Response to Submissions Report

**Kembla Grange Resource Recovery Facility
Building Material Storage and
Resource Recovery Facility Exceeding 30,000 Tonnes per Annum and
Redesign and Expansion of Approved Facility**

**Lot 10 DP 878167
50 Wyllie Road, Kembla Grange
Application No. SSD-5300**

**by TCG Planning
20 May 2015**

Figure 6: Predicted Annual Dust deposition (with mitigation) g/m³/month Ref: Air Quality Assessment (Figure 17), GHD, April 2015

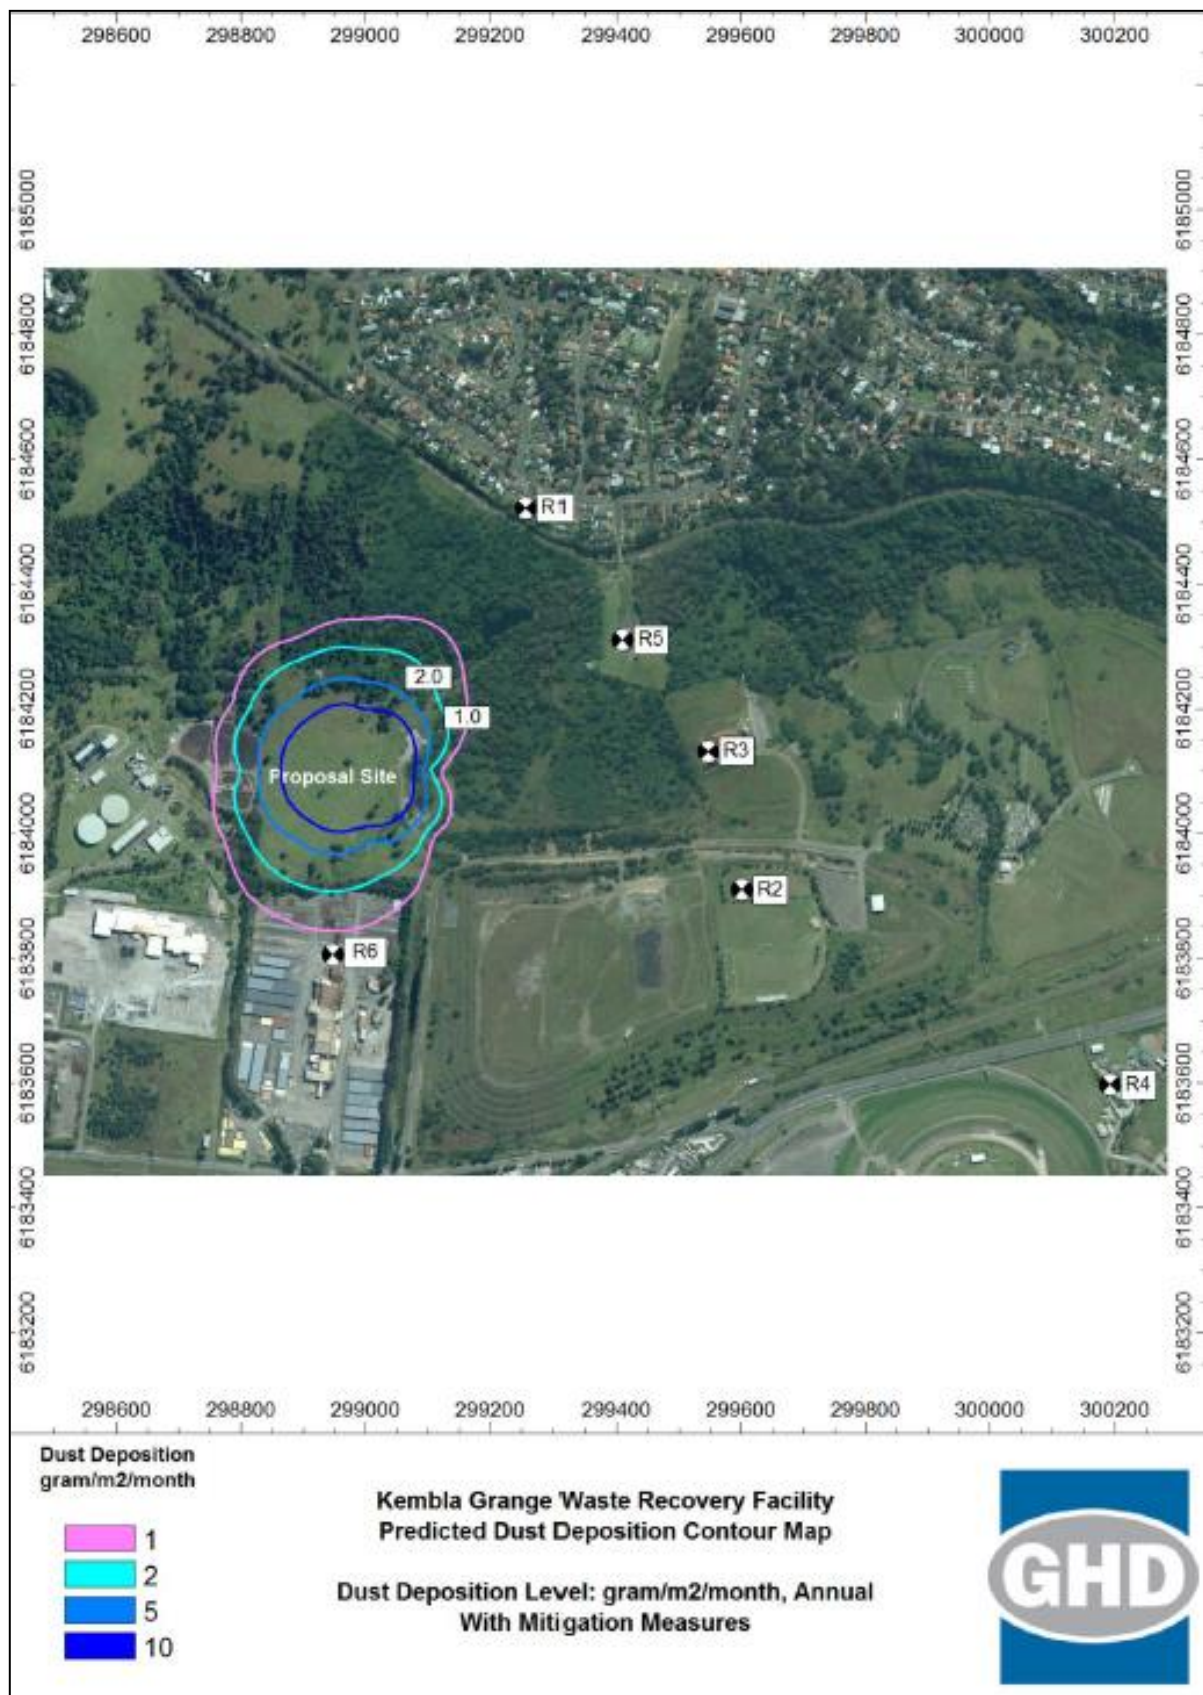
been undertaken to show that dust deposition levels are predicted to be below the criteria on the entire site".

Following modelling , which has been conducted by GHD in accordance with the Approved Methods (OEH assessment criteria). GHD conclude within Section 8 of the AQA (April 2015) that:

Figure 7: Predicted Peak Odour Contour Map, OU with Building Ventilation Ref: Air Quality Assessment (Figure 19), GHD, April 2015

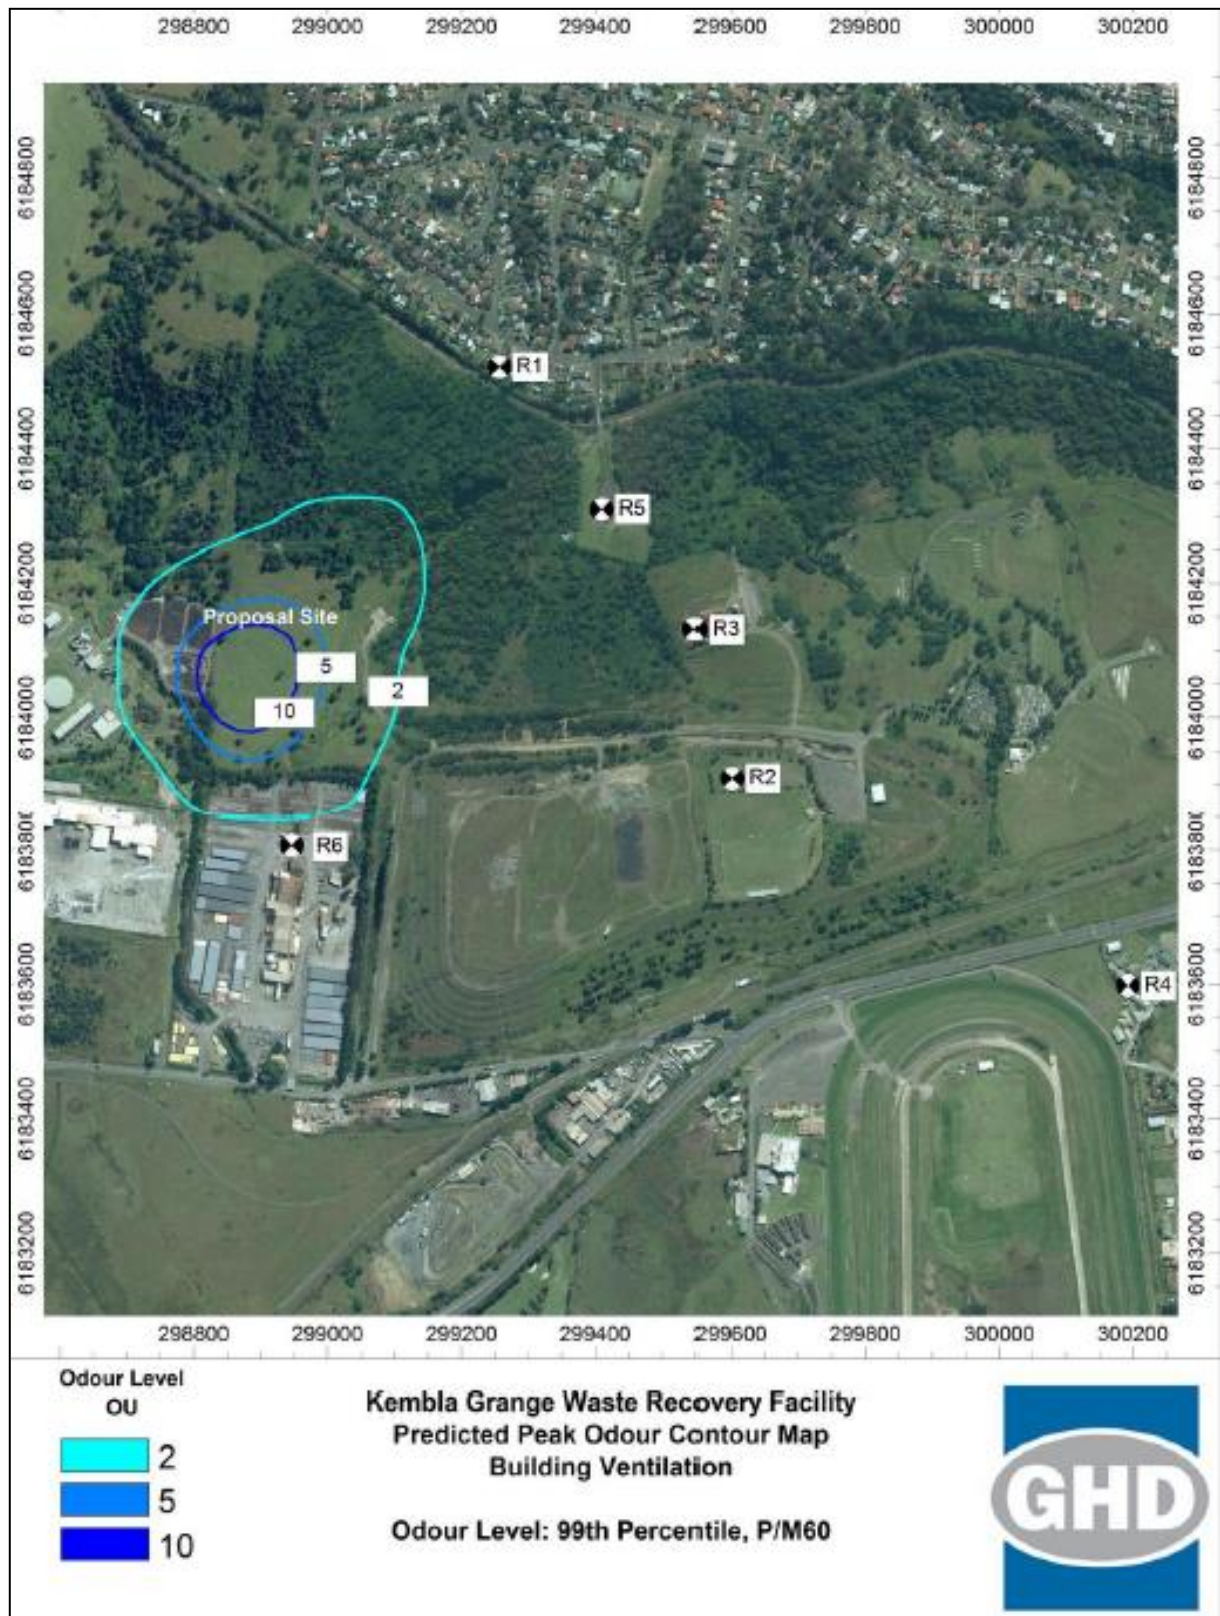
- The facility be constructed *"so as not to preclude the retrofit of additional control measures such as a biofilter if required"*.
- The proponent considers *"additional odour mitigation measures relating to the leachate pond and management of organic waste and mature compost stockpiles including coverage of the later to prevent ingress of water and minimising onsite storage time prior to processing and/or removal offsite as part of the air quality management plan for the facility."*
- *Odour auditing requirements will need to be includes as part of the environmental protection licence conditions for the facility to ensure that any potential issues from these sources are addressed as required once operations commence"*.

Following review of the submission received GHD has reconsidered the option available to odour mitigation. As a result of this further assessment the odour mitigation assessment has been modified and the use of a biofilter has been removed. GHD confirm that the use of a building ventilation with all building air emitted through a stack as originally assessed increases dispersion into the surrounding environment and reduces the predicted odour levels to meet the criteria at all identified sensitive receptors. Based on predictions in the assessment, there is no need for the inclusion of a biofilter to meet the criteria. **Figure 7** which is extracted from the Air Quality Assessment (Figure 19) shows the predicated odour contours with building ventilation and GHD confirm that *"based on the assumptions made in this assessment, predicted odour levels form the proposed green waste composting will comply with the criteria if the WRF building is kept at negative pressure and all air if released in to the atmosphere via a stack"*.

The following additional odour management measures are therefore recommended to address the matters which were specifically raised by the EPA:

Figure 8: Draft West Dapto Masterplan 2013 (Ref: Wollongong Development Control Plan 2009, Wollongong City Council - Nb. Clarity limited in original document).

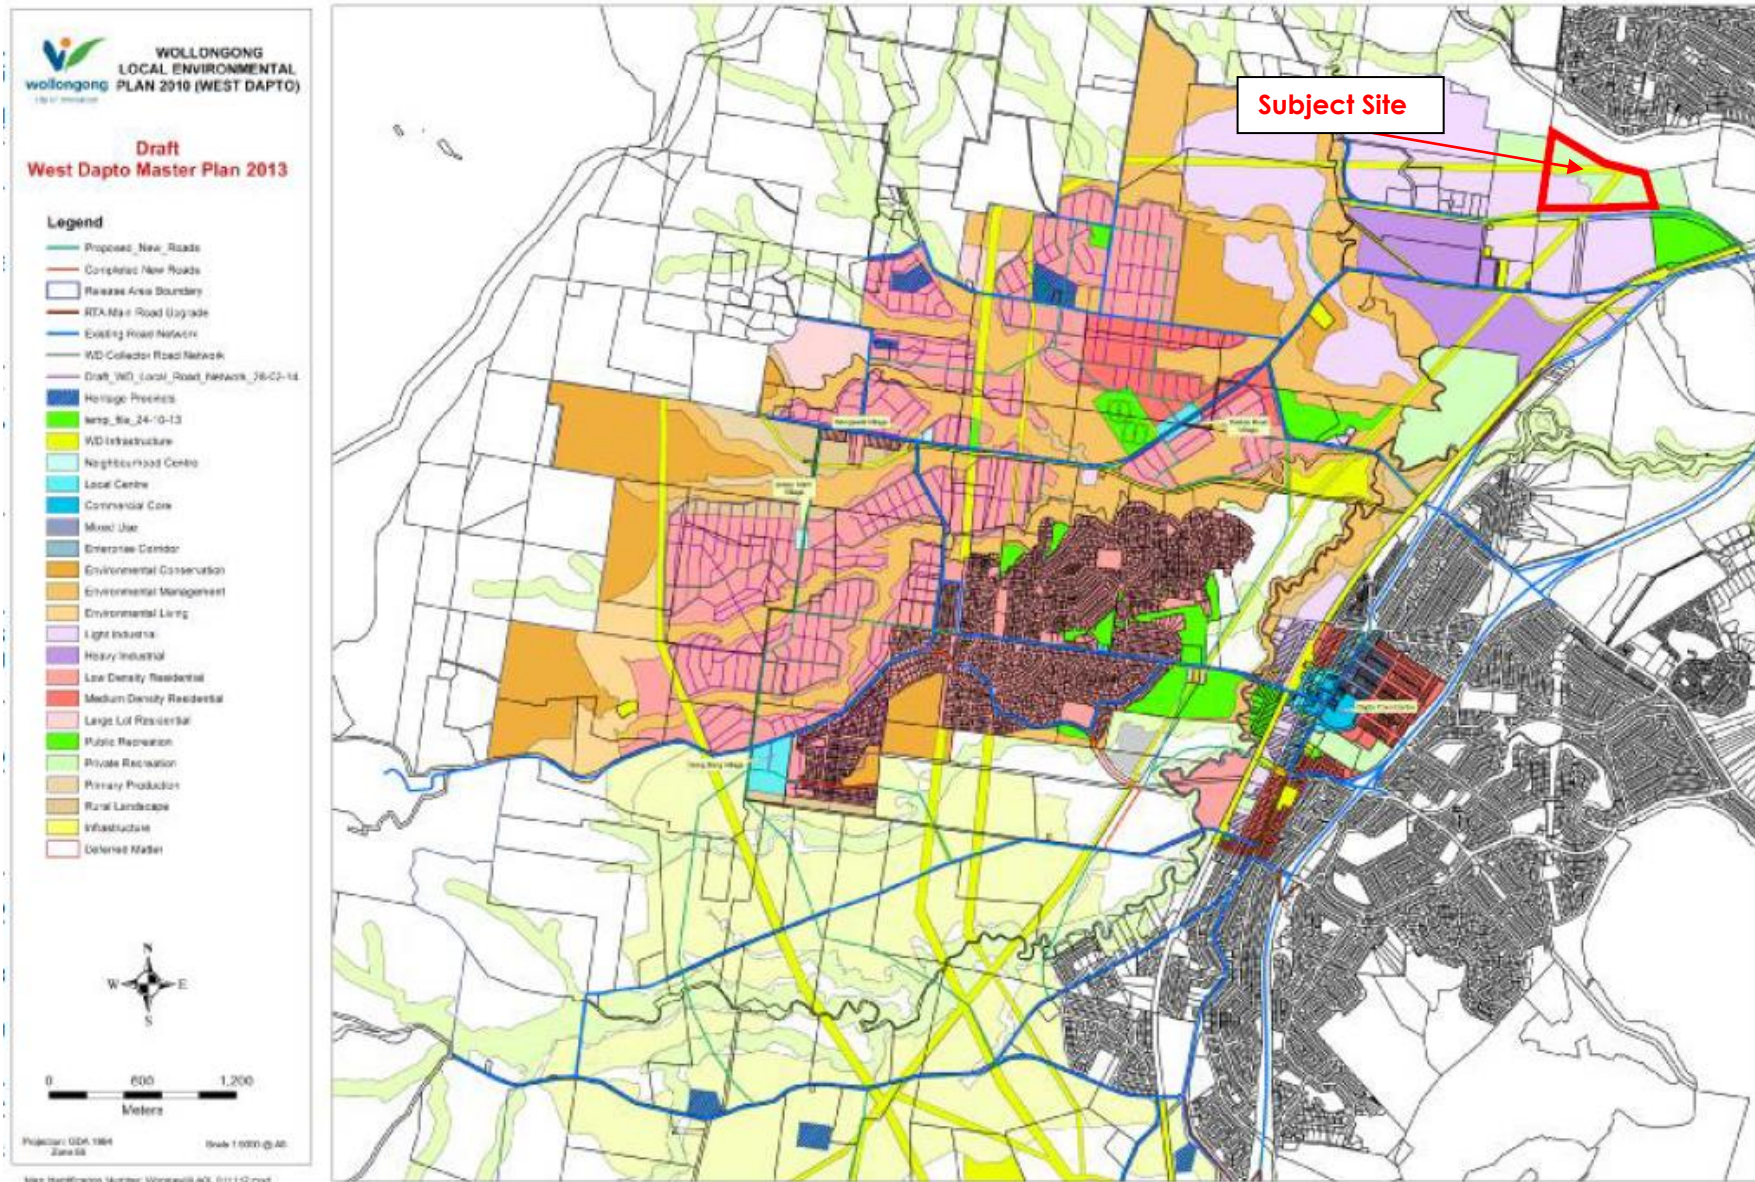
As stated by Cardno *"the land surrounding KGRRF and Patrick these activities are likely to expand in future given the growth of Wollongong, and hence the need for greater employment in the area and future residential development of the greater West Dapto area. The future land use of West Dapto is outlined in Wollongong City Council's Wollongong Development Control Plan 2009, Chapter D16: West Dapto Release Area. The West Dapto Master Plan (see figure 7) indicates that the land surrounding the KGRRF to the south and south east is intended for light industrial development"*. Cardno on behalf of PAC believe the proposal does not adhere to best practice design as required to be considered under SEPP (Infrastructure) 2007 and this concern has not been adequately addressed in the EIS. Specifically, PAC are concerned that the proposed expansion of operations at the subject site will produce levels and types of dust and air pollution that will create a land use conflict with PAC's operations in the area.

As noted on the Cardno submission Chapter D16: West Dapto Release Area of Wollongong Development Control Plan 2009 contains a Draft West Dapto Masterplan 2013 which replaces the West Dapto Masterplan 2009, as referenced in the Cardno submission. This Masterplan also provides guidance as to the future land uses in this locality. An extract of this Masterplan is contained in **Figure 8**. This Masterplan shows that, consistent with the zoning of WLEP 2009, land to the southwest and south is to be used for Light industrial uses, whilst further beyond heavy industrial uses are encouraged.
